SUBJECT: Additional Response to Questions on Generic Letter 96-06

Enclosed are additional responses and clarification to our previous letter that responded to questions raised on the document "Resolution of Generic Letter 96-06 Waterhammer Issues", EPRI Interim Report TR-113594--V1 & V2, December 2000. The attachment to this letter includes responses to specific questions raised by the NRC. This information will be added to the final revision of the Technical Basis Report.

Figure 10-8a: Rise Time vs. Non-cushioned Impact Velocity

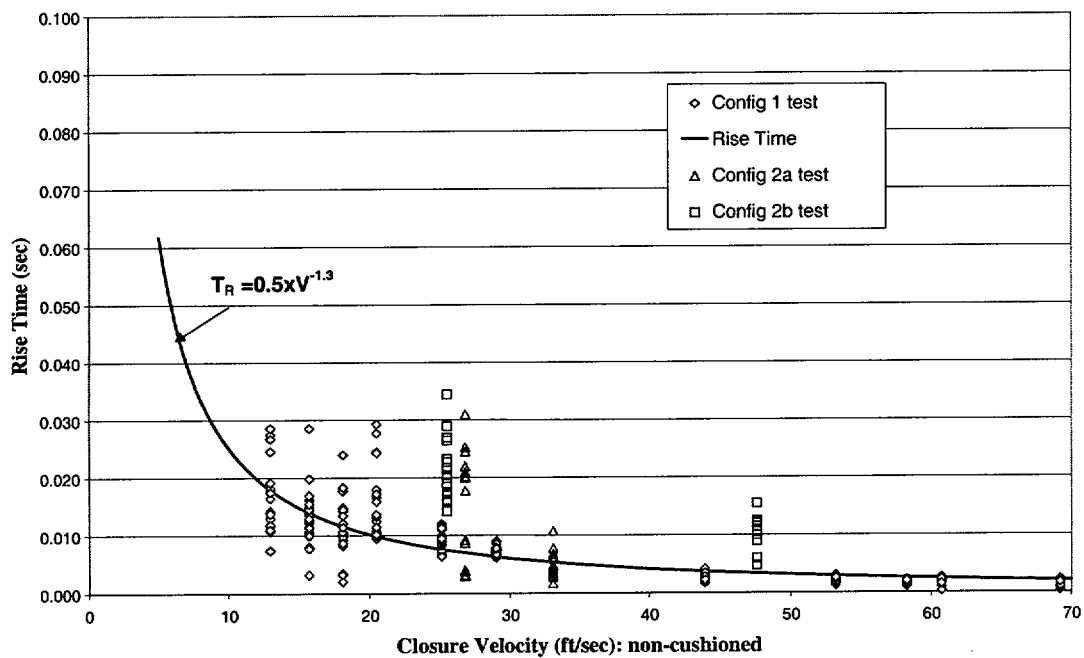
- 1. The relationship of pressure rise time to impact velocity is given only for test configuration No. 1 which did not include air in the steam void. Please provide a comparison of the pressure rise time relationship with the data from test configuration 2 which did include air.**

The individual rise times for the Configuration 2a and 2b tests have been calculated. This data is provided in Figure 10-8 in the referenced letter. That figure utilized calculated "cushioned" velocity for the abscissa. The ordinate is test data; the abscissa is calculated. The rise time test data has also been plotted against the "uncushioned velocity". A figure showing the rise time versus the "uncushioned" velocity is attached to this letter and is referred to as Figure 10-8a. The uncushioned velocity is a parameter that is much more accurately calculated since it is dependent only on the system hydraulics and not the dynamics of void closure. The uncushioned velocity is readily known for the plant configurations. Note that in Figure 10-8a the rise time equation generally falls on or under the Configuration 2 test results. This is conservative since using a shorter rise time produces higher differential pressures across a pipe segment, and therefore, higher loads. Configuration 2b best represents the plant configuration as it has a longer column than test 2a. Referring to Figure 10-8a, it can be seen that the Configuration 2b test results are all conservative (have longer rise times) relative to the rise time equation recommended for use.
